CONTRACTOR RESPONSIBLE FOR ENSURING APPROVED DWGS ON SITE AT TIME OF INSPECTION

- A0 TITLE SHEET
- A1 BASEMENT PLAN ELEV. 'A' & 'B'
- A2 GROUND FLOOR ELEV. 'A'
- A3 SECOND FLOOR ELEV. 'A'
- A4 PARTIAL ALT. KITCHEN LAYOUT
- A5 GROUND FLOOR ELEV. 'B'
- A6 SECOND FLOOR ELEV. 'B'
- A7 FRONT ELEVATION 'A'
- ROOF PLAN ELEV 'A'
- A8 RIGHT SIDE ELEVATION 'A'
- A9 REAR ELEVATION 'A' & 'B'
- A10 LEFT SIDE ELEVATION 'A'
- A11 FRONT ELEVATION 'B'
- ROOF PLAN ELEV 'B'
- A12 RIGHT SIDE ELEVATION 'B'
- A13 LEFT SIDE ELEVATION 'B'
- D1 CONSTRUCTION NOTES
- D2 CONSTRUCTION NOTES
- D3 CONSTRUCTION NOTES

Tice River Homes Legacy

LEFT SIDE ELEVATION 'B'

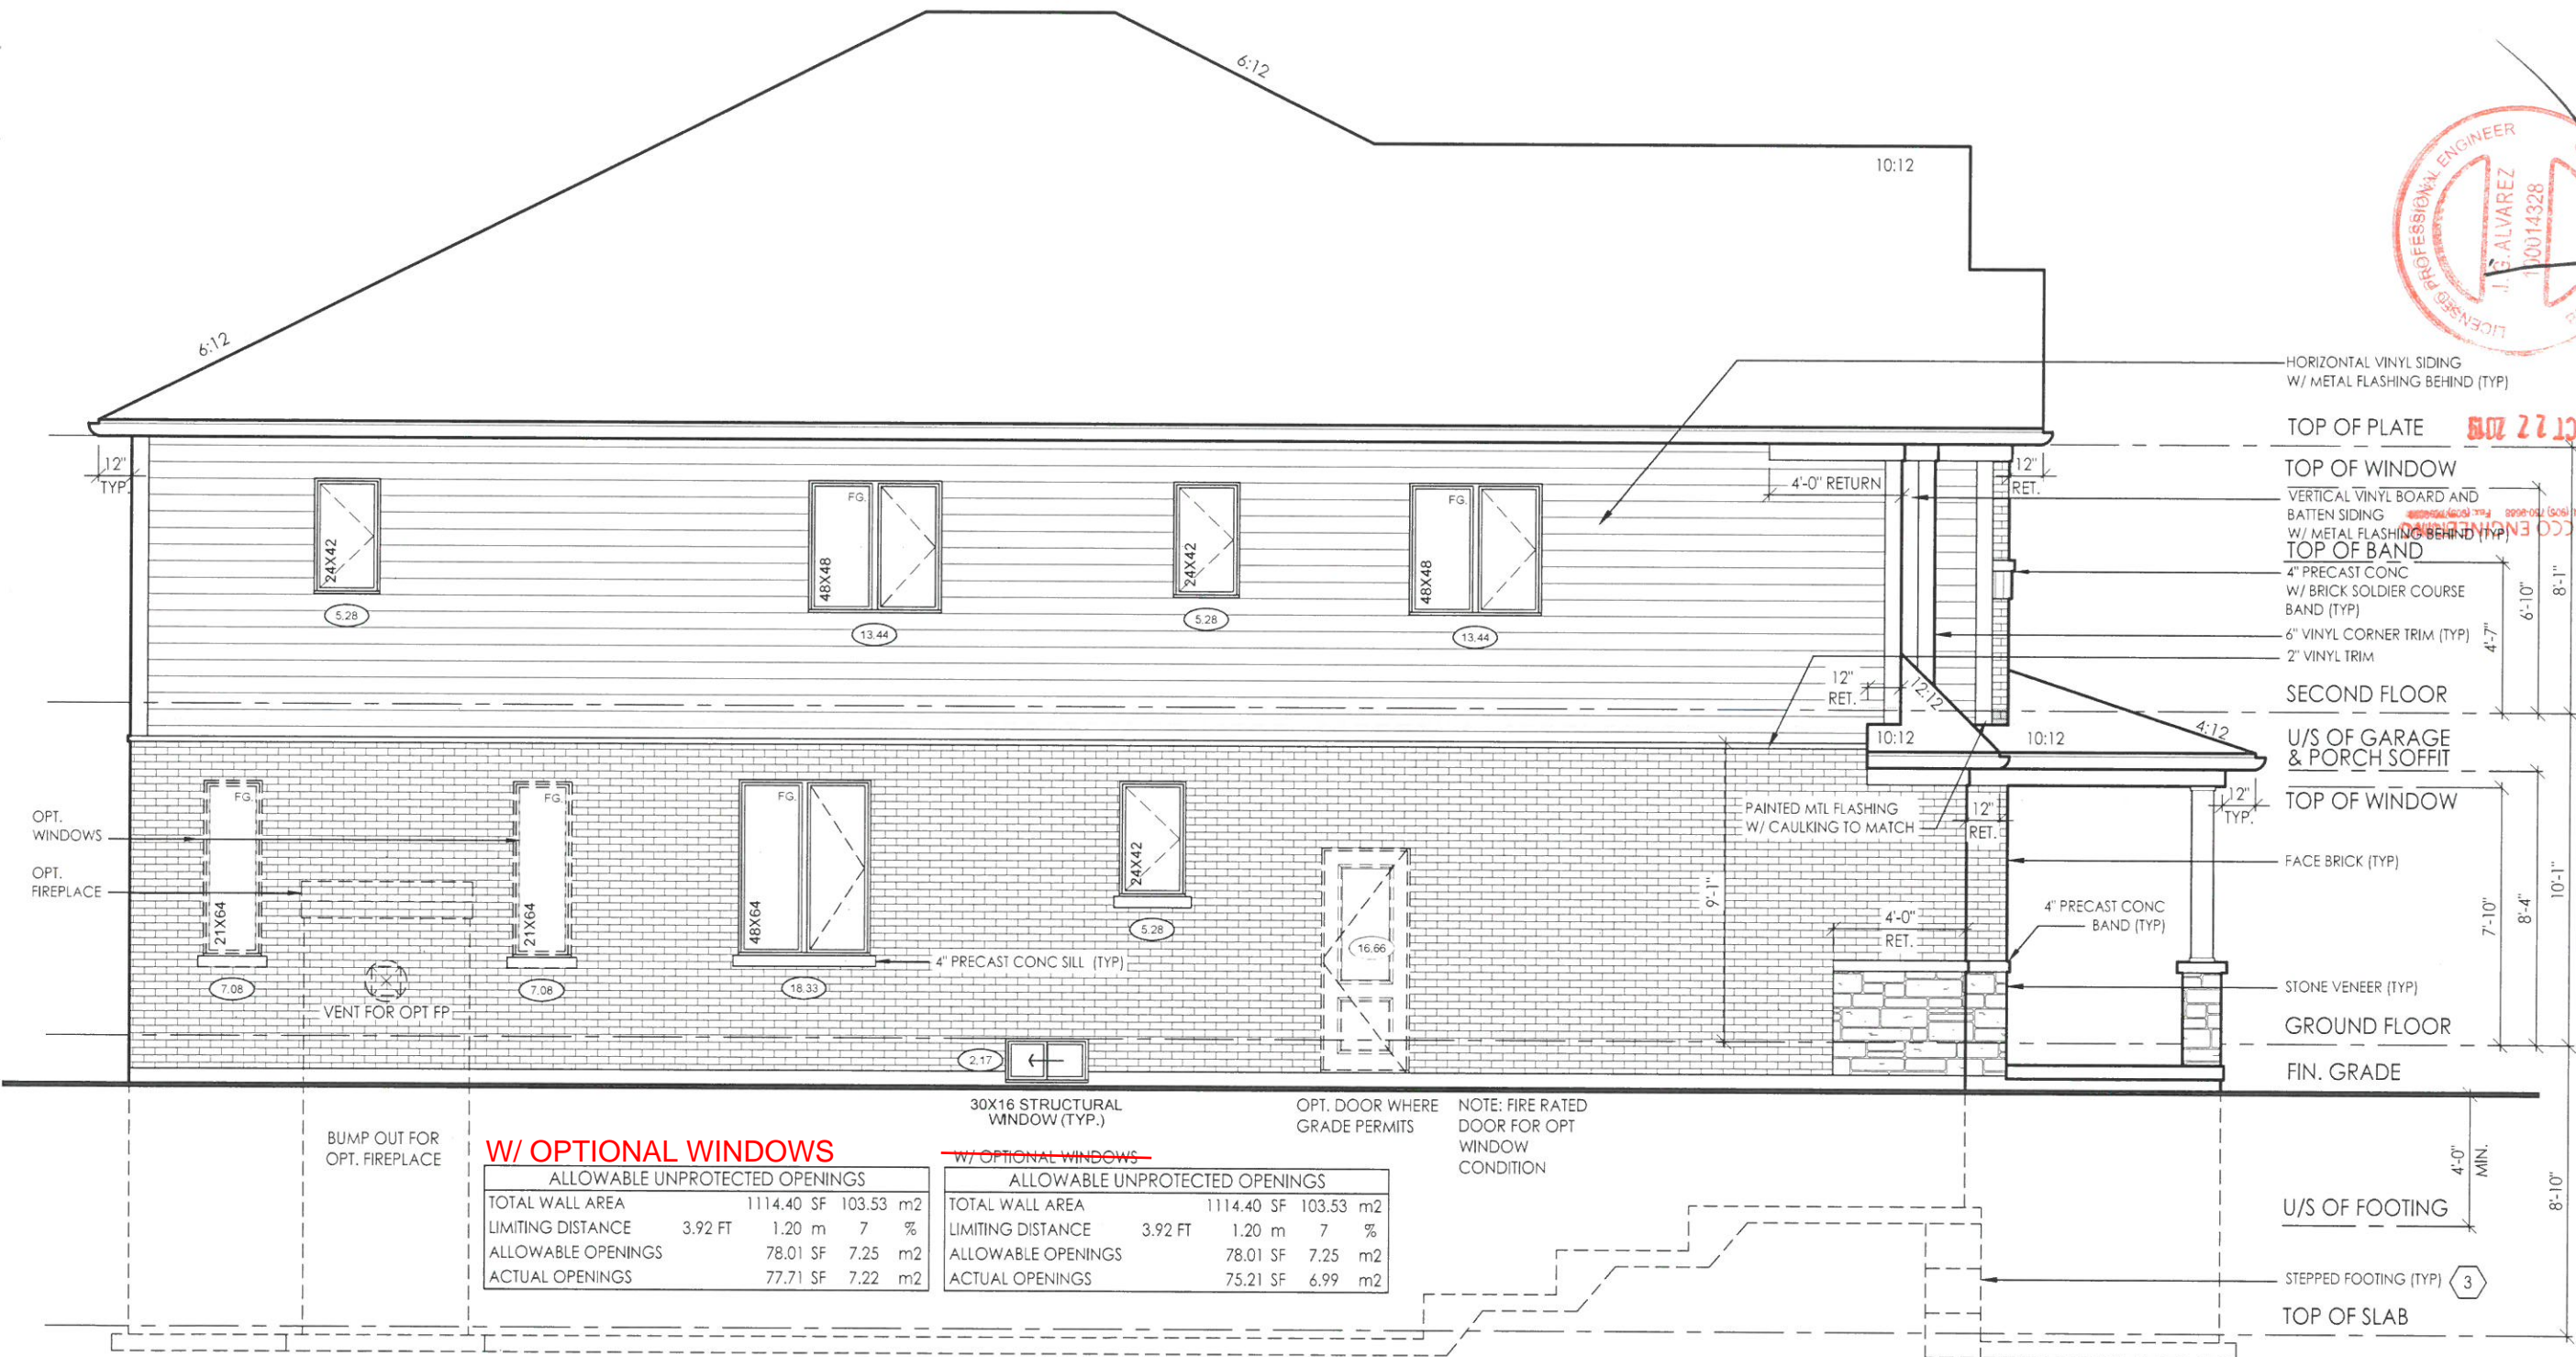
WINDOW WELLS OR 6" CLEARENCE TO GRADE
